INTERNATIONAL STANDARD

AMENDMENT 2 AMENDEMENT 2

**Electromagnetic compatibility (EMC) –
Part 3-2: Limits – Limits for harmonic current emissions (equipment input
current ≤ 16 A per phase)**

Figure 2 – Illustration of the relative phase angle and current parameters described in 7.3 b)

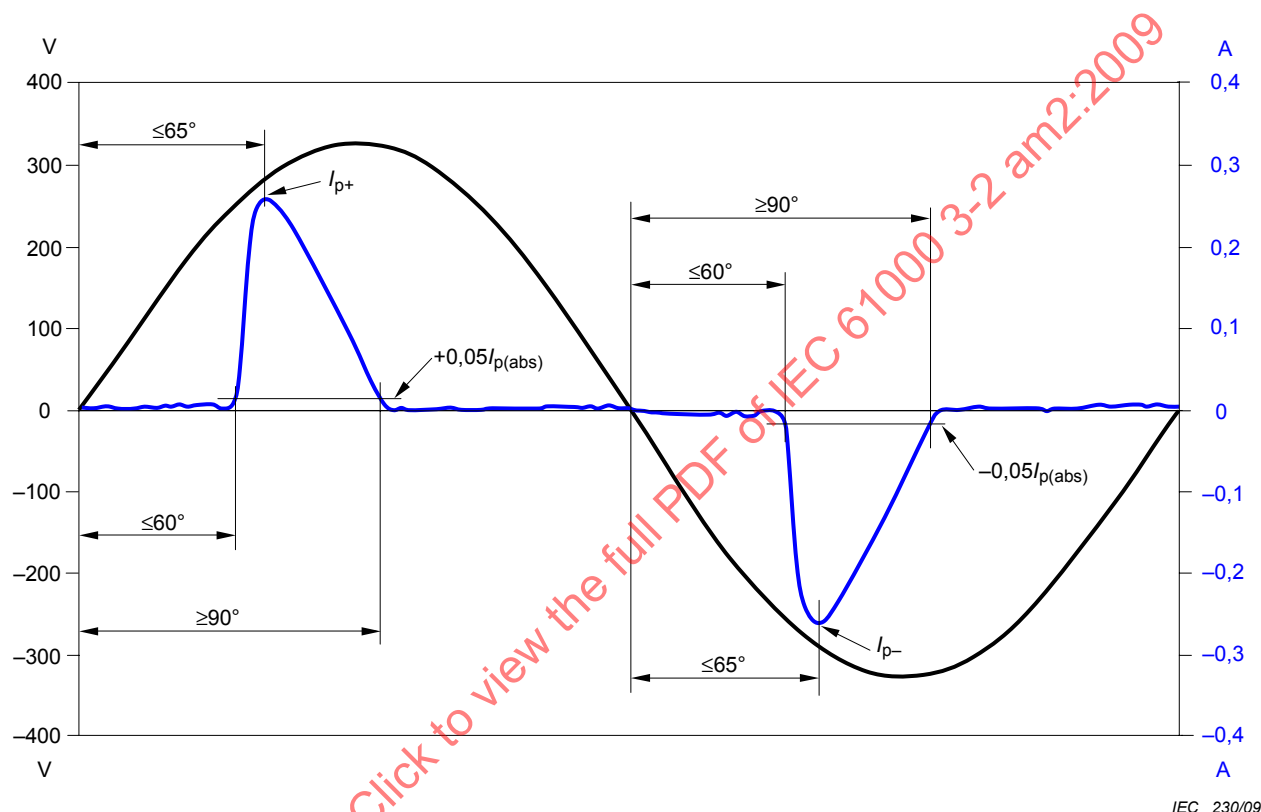
7.3 Limits for Class C equipment

- a) Active input power > 25 W

Add, at the end of the third dashed item:

(see the last paragraph of C.5.3).

Figure 2 – Illustration des caractéristiques en déphasage relatif et en courant décrites en 7.3 b)

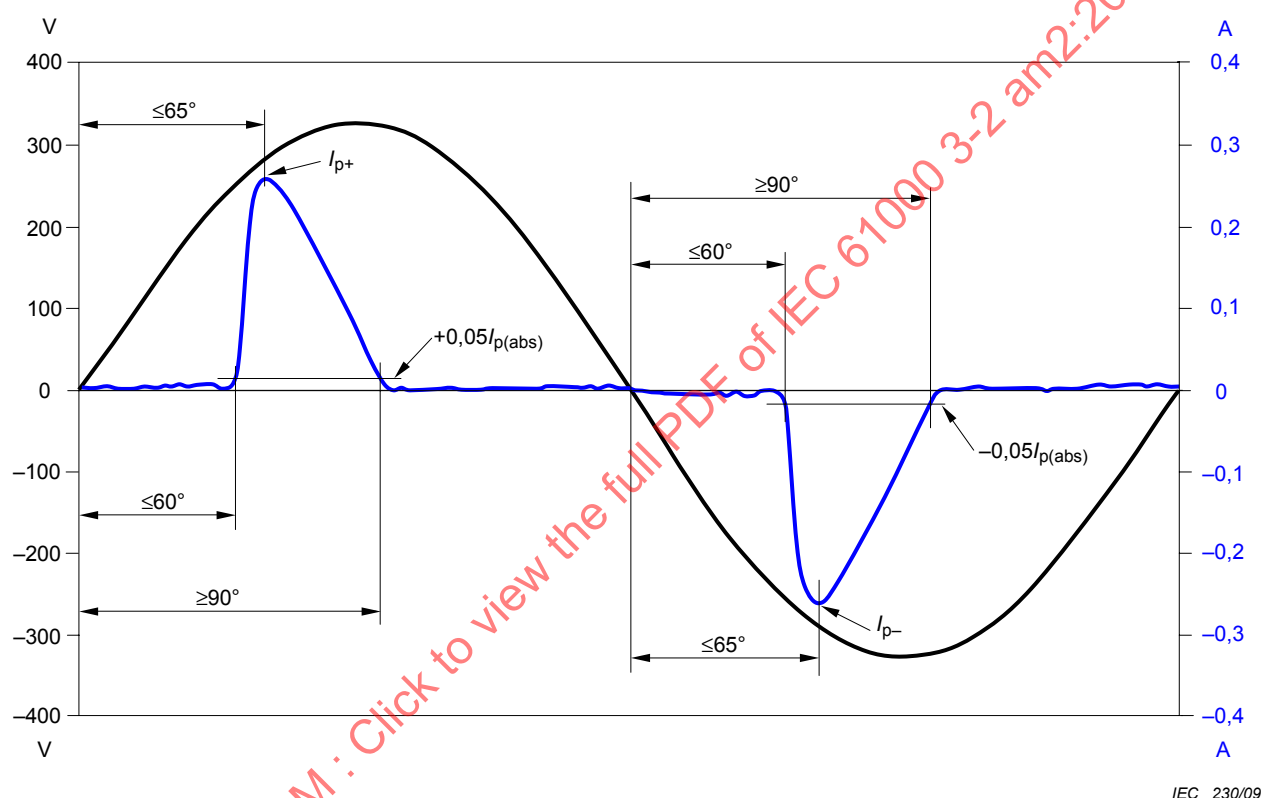
7.3 Limites pour les matériels de Classe C

a) Puissance active d'entrée > 25 W

Ajouter, à la fin du texte du troisième tiret:

(voir le dernier alinéa de C.5.3).
